## CITY OF ALBUQUERQUE

Site: Juan Tabo Hills Estates

Re: Drainage Ordinance (14-5-2-1) Violations for Erosion and Sediment Control

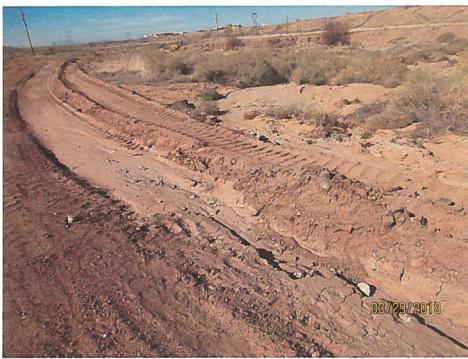
- 1. Silt fence is not installed properly, as it is not buried along the southern edge in the southeast areas of the site.
- 2. Grading in the southwest corner of the site directs flows into an undersized ponding area with an uncompacted berm rather than into the stormwater quality pond.
- 3. Loose soil in the low-flow area of the channel and berm not compacted adjacent to the arroyo.
- 4. Self-inspection reports were not provided upon request.

Silt fence not installed properly, it is not buried.

- 1. Reinstall silt fence per the approved Erosion and Sediment Control plan along the southern edge in the southeast area of the site. Silt fence is to be installed and maintained per the approved plan.
